ADDENDUM NUMBER 2:

Re: Crescent Lake Outfalls
Specification Number: PD 15-16.033

Revised Bid Documents

**PLANS PROPOSED FOR
 ENGFLOOD0414-91H
 CRESCENT LAKES
 OUTFALLS**

W1 - PLAN / PROFILE

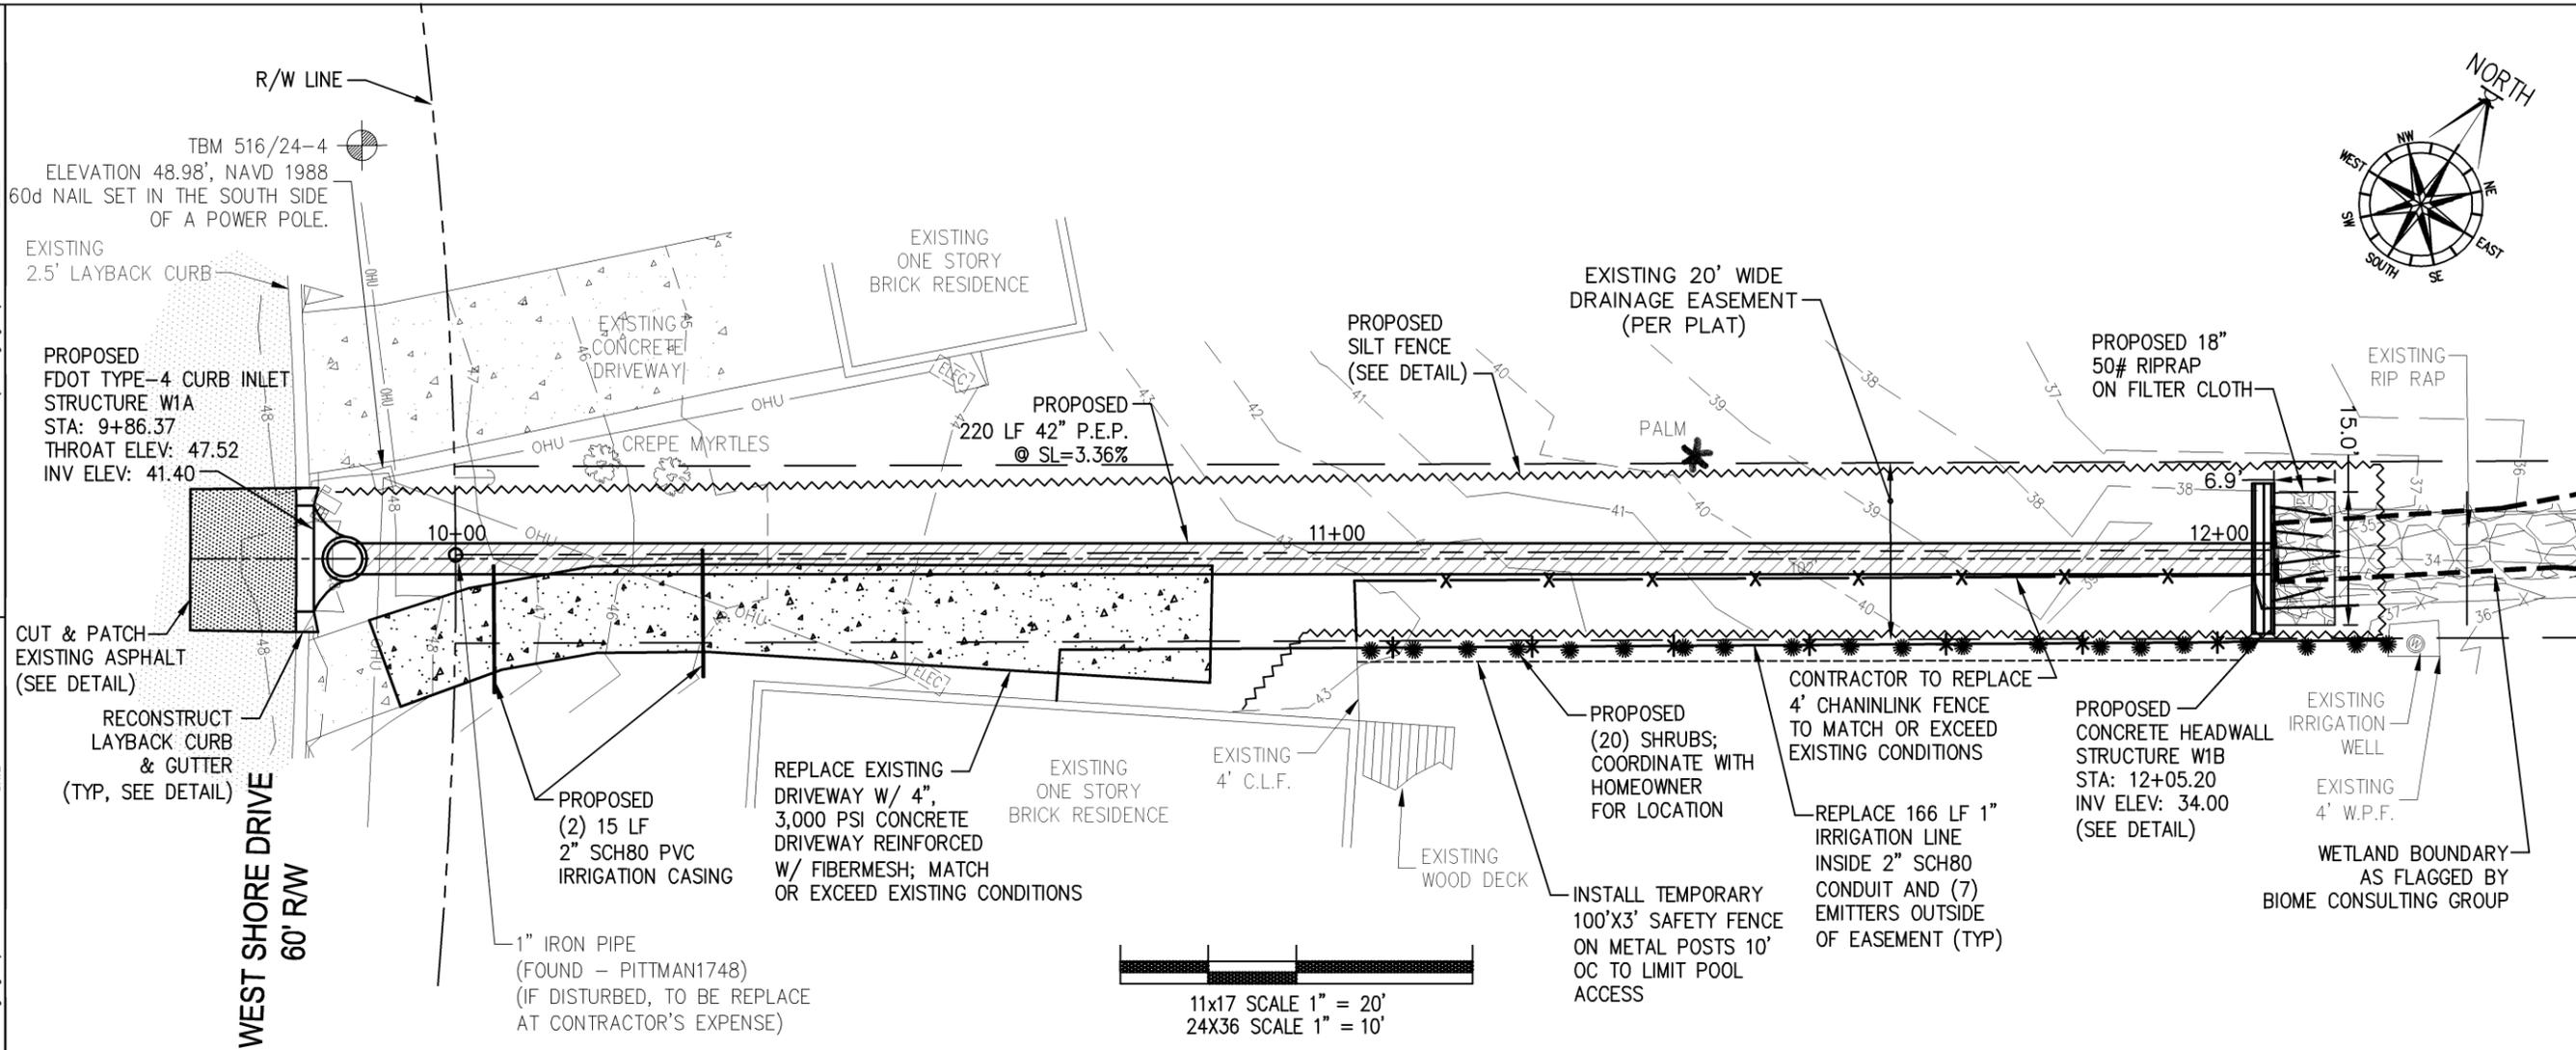
The existing curb inlet, storm pipe, and headwall are to be removed & replaced. The existing concrete driveway, fencing, irrigation system, and landscaping are to be removed & replaced as needed. West Shore Drive is to be cut & patched as required to replace the curb inlet. Safety fence is to be installed temporarily while the 4' chainlink fence is down.

W3 - PLAN / PROFILE

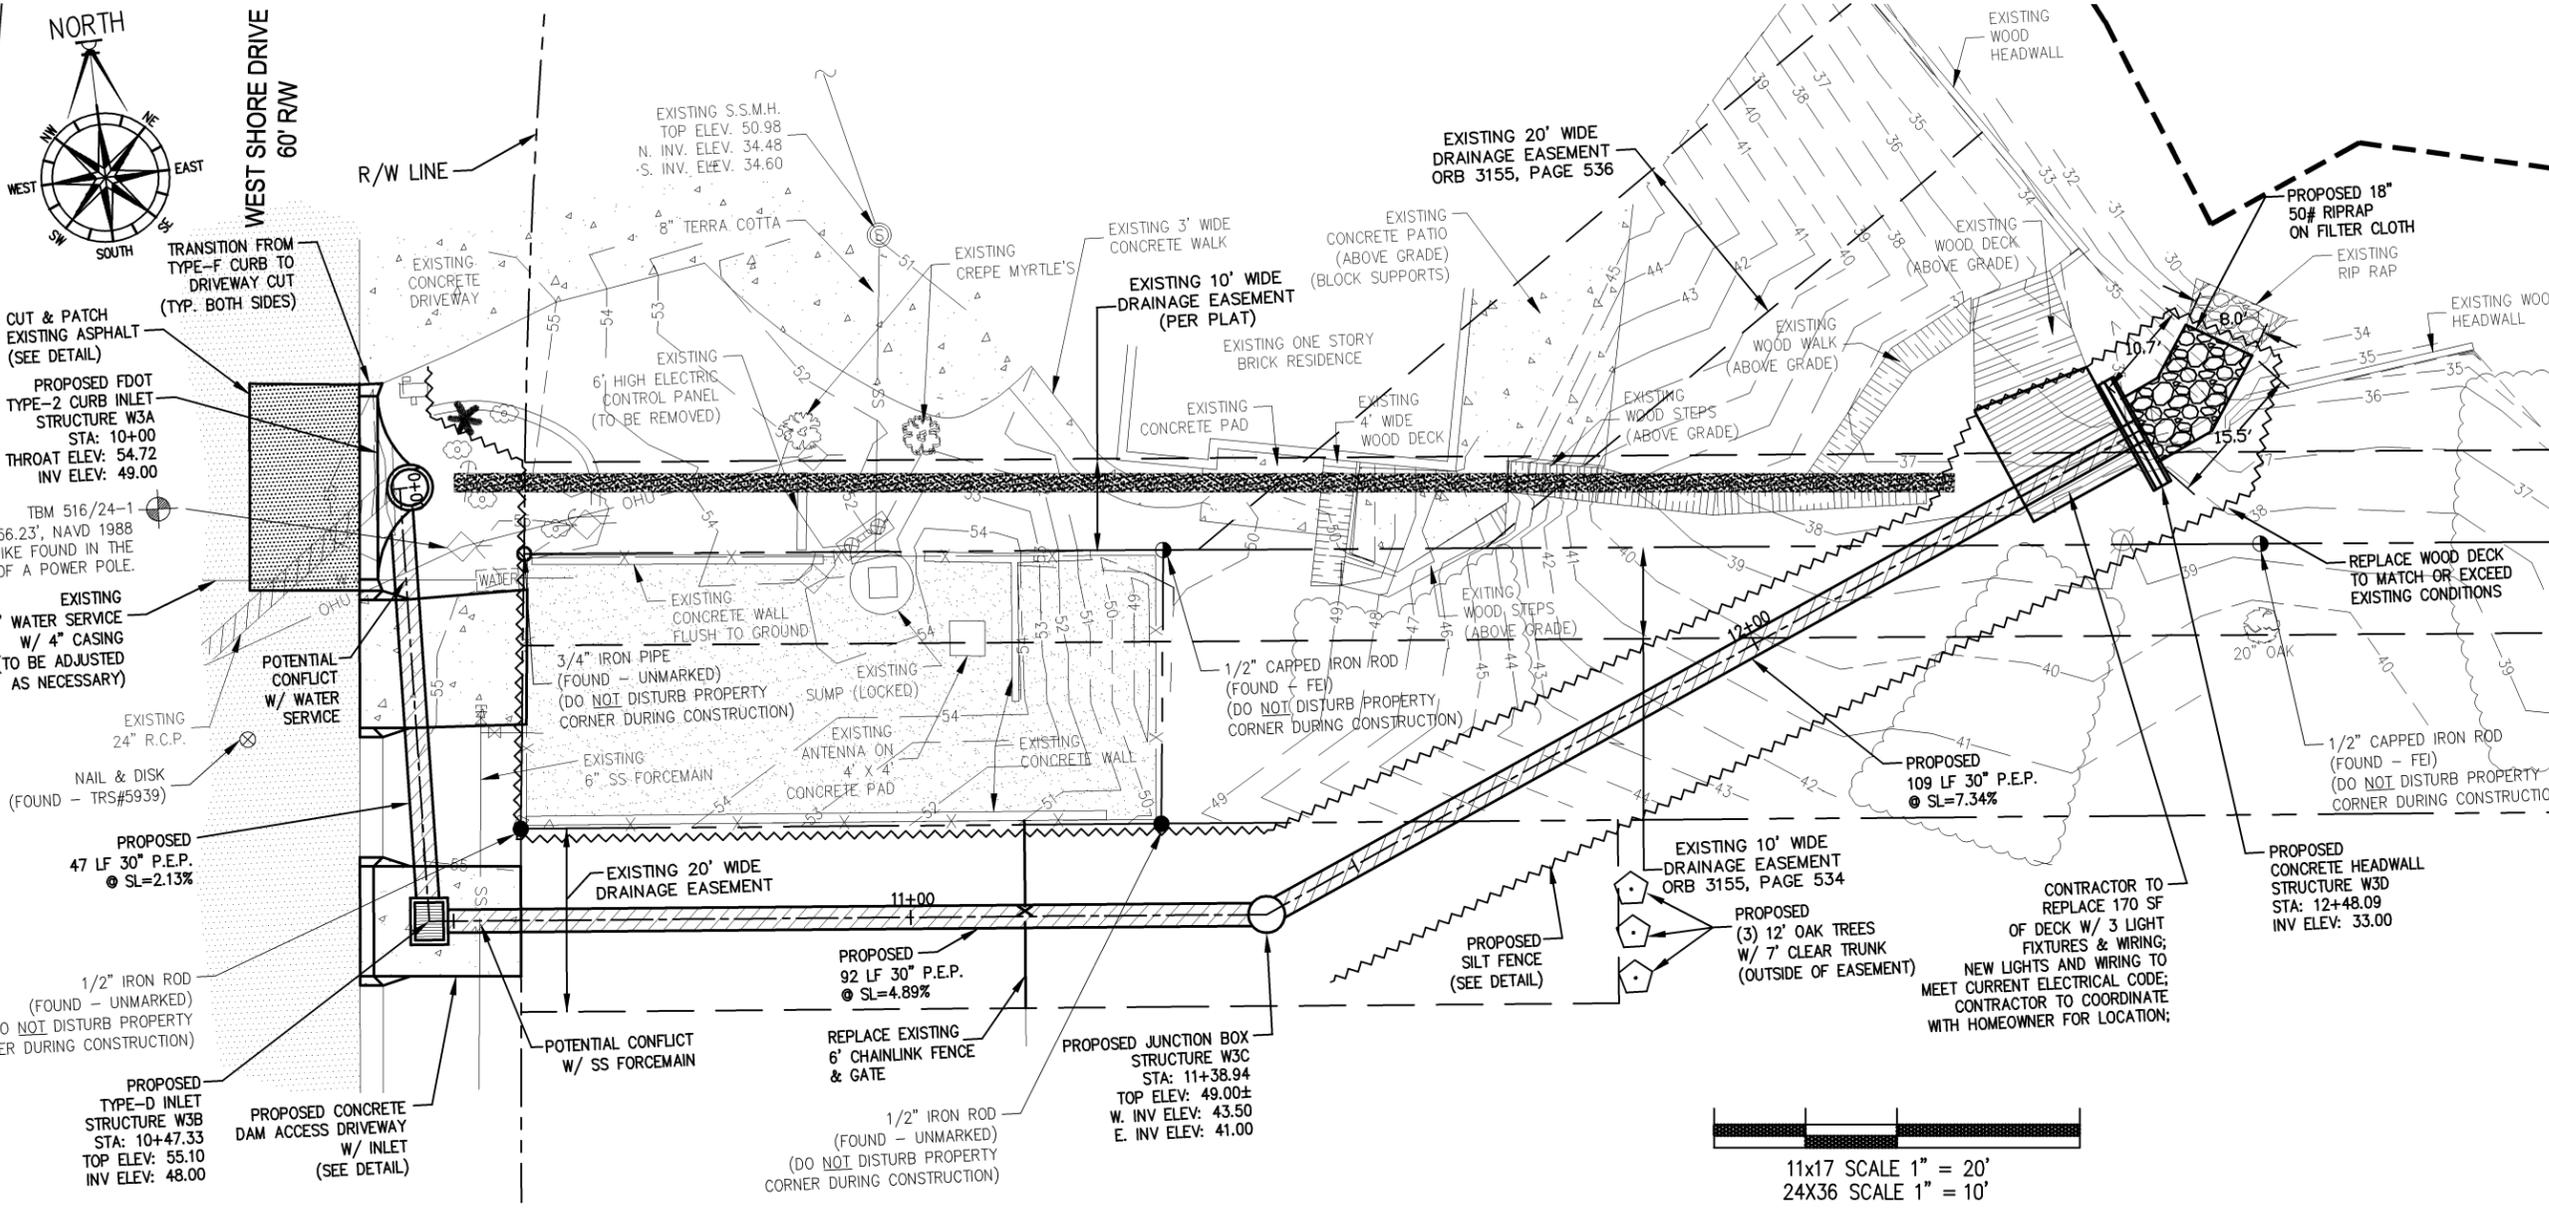
The existing stormwater pipe is too close to the existing residence to be disturbed. The stormwater is to be rerouted around the south side of the existing ECUA pumpstation. A new concrete driveway is to be constructed to provide access to the Crescent Lake dam. Within this driveway, a drop inlet is to be installed to help catch stormwater that may overwhelm the curb inlet. The existing abandoned pipe is to be filled with flowable fill. The existing deck at the headwall location is to be removed & replaced with a similar deck with electrical features. West Shore Drive is to be cut & patched as required to replace the curb inlet. The existing ECUA concrete driveway, fencing, and landscaping are to be removed & replaced as needed. The water service to the ECUA pumpstation and forcemain coming out of the pumpstation are potential conflicts. The proposed stormwater pipe should be under the existing forcemain. The water service is to be adjusted as needed.

CRESCENT LAKES OUTFALLS
E1 - PLAN / PROFILE

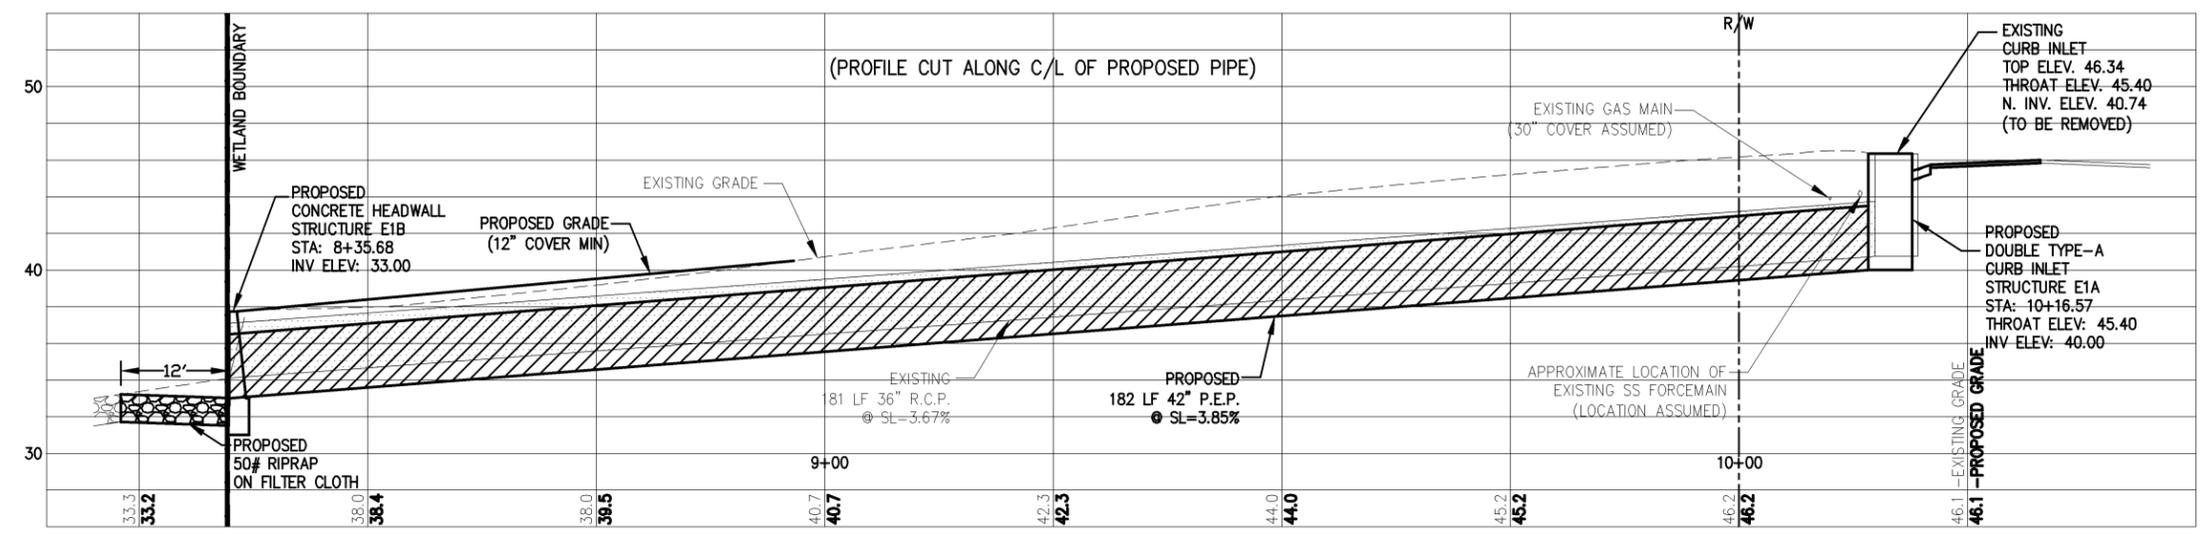
The existing curb inlet, storm pipe, and headwall are to be removed & replaced. The existing fencing is to be removed & replaced as needed. East Shore Drive is to be cut & patched as required to replace the curb inlet. The proposed storm pipe will cross a force main and gas main. The pipe should be under both utilities without conflict.
